Staff Report Z-48-19-8 November 1, 2019

Request From: IND.PK. ([Industrial Park](#)) (2.64 acres)

Request To: C-2 ([Intermediate Commercial](#)) (2.64 acres)

Proposed Use: Auto Parts Retail Store

Figure C. Development Site Plan

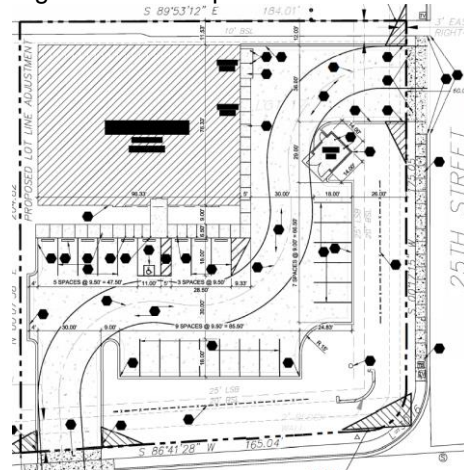
5. Staff is recommending several stipulations to govern the development of the full site area in terms of site function.

The site has significant roadway frontage including direct frontage onto Southern Avenue, an arterial street. Staff is recommending enhanced landscape setbacks and planting standards to increase thermal comfort, visual appearance, and shade pedestrian paths in proximity to transit services.

Staff is recommending pedestrian enhancements to increase the walkability of the area due to its proximity to transit services and its role as an arterial street. These pedestrian enhancements include detached and shaded public sidewalks and private walkways that are clearly delineated and connect all buildings on the site to one another and public sidewalks (Stipulation Nos. 4 and 5).

3. A minimum 25-foot landscape setback shall be required adjacent to Southern Avenue and 25th Street and planted with large canopy shade trees. Fifty percent of the trees shall be minimum three-inch caliper and 50 percent shall be minimum four-inch caliper. Trees shall be placed 20 feet on center or in equivalent groupings, as approved by the Planning and Development Department.

4. The public sidewalk shall be detached from Southern Avenue by a minimum eight-foot-wide landscape area and from 25th Street by a minimum five-foot-wide landscape area located between the sidewalk and back of curb; the landscape areas shall be planted to the following standards, as approved by the Planning and Development Department:

5. The developer shall provide accessible pedestrian pathways as described below and as approved by the Planning and Development Department:
 - a. Pathways shall connect the front entrances of all buildings developed on the site.

Figure 6: Zoning Separation Diagram

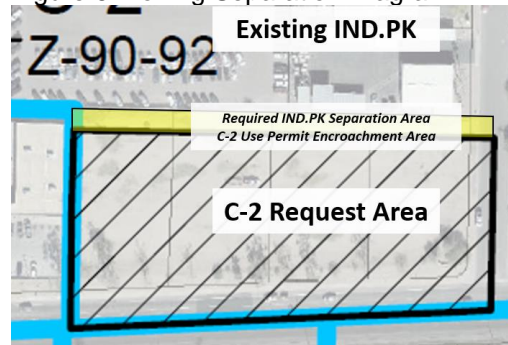
Properties zoning IND. PK. utilize Commerce Park (CP) district standards. To mitigate potential compatibility issues, the IND. PK district requires a 25-foot minimum setback adjacent to the perimeter of the district. Consequently, if the full subject property were rezoned, the development to the north (zoned IND. PK.) would be made non-conforming due to its proximity to the C-2 zoning.

To mitigate this issue, the applicant has shifted the rezoning request 25-feet to the south of their north property line to absorb the required 25-foot perimeter setback.

If the request is approved, the applicant intends to pursue a Use Permit through [Section 307.A.8](#) to allow the proposed C-2 use to encroach onto the remaining IND.PK. section of their property. Through a Use Permit, a use permitted in a more restrictive zoning district (such as C-2) can encroach into a less restrictive zoning district (such as IND. PK.).

1 SOUTH EXTERIOR ELEVATION
CE1 SCALE: 1/8" = 1'-0"

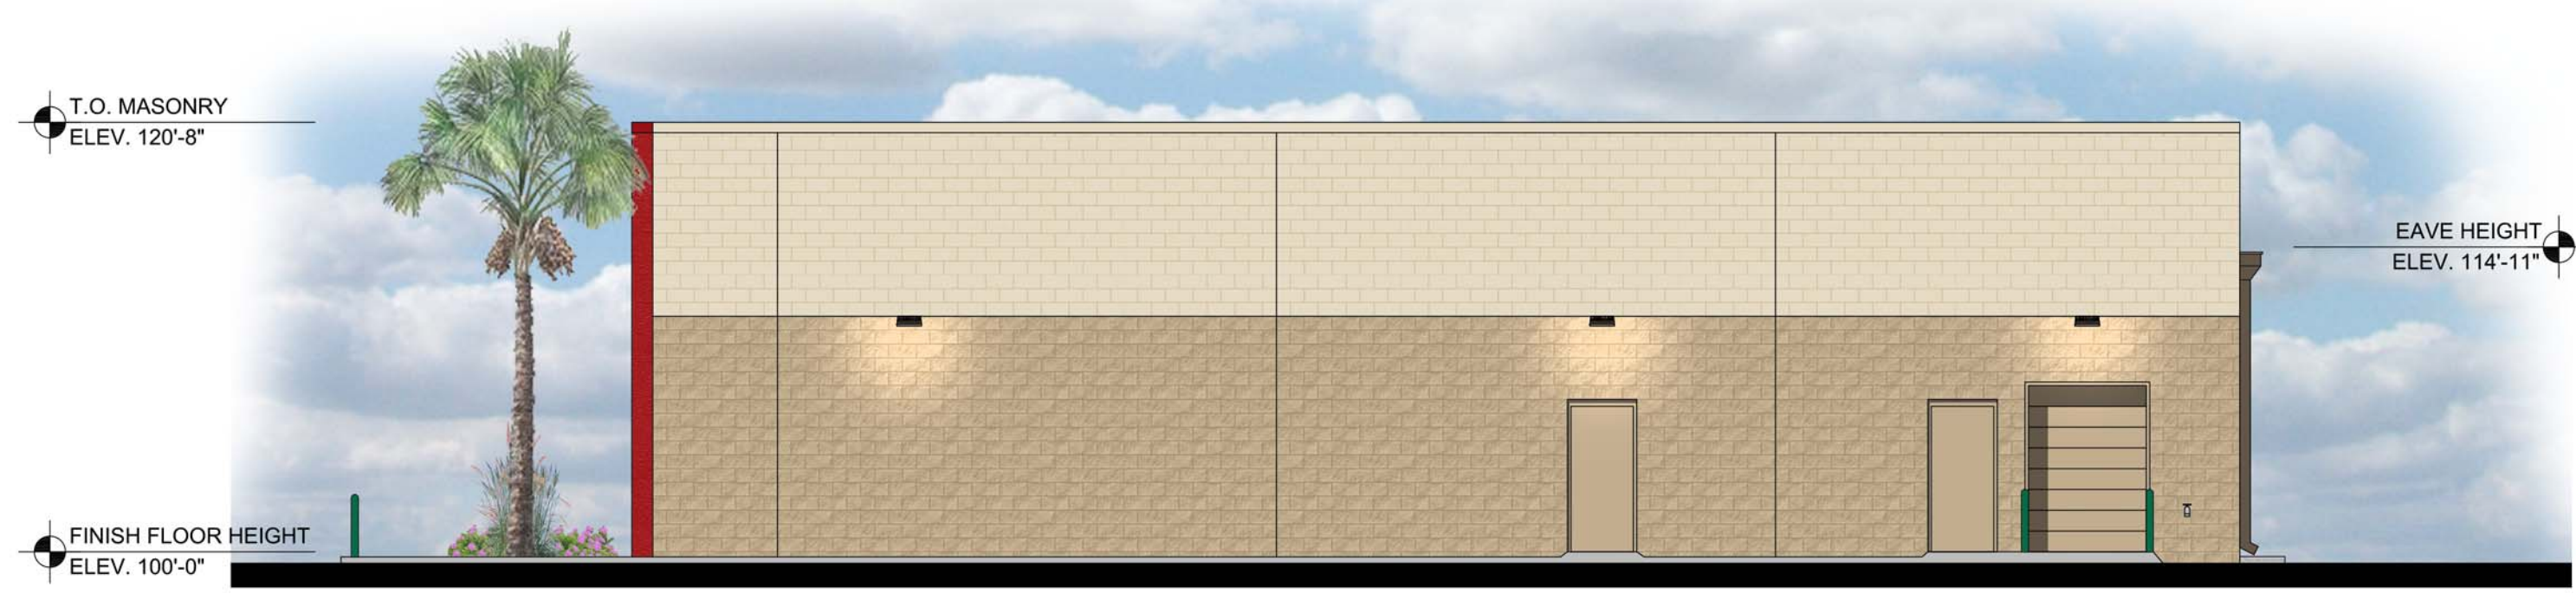
The development proposal included elevations for the auto parts retail facility. The south elevation contains variations in materials, colors, and textures.

The applicant has provided elevations only for the eastern development area. To ensure design continuity and quality for all buildings on the site, staff is recommending a stipulation to require architectural enhancements including detailing and embellishments (Stipulation No. 1).

1. All elevations of all buildings shall contain architectural embellishments and detailing such as textural changes, pilasters, offsets, recesses, variation in window size and location, and/or other overhang canopies, as approved by the Planning and Development Department.
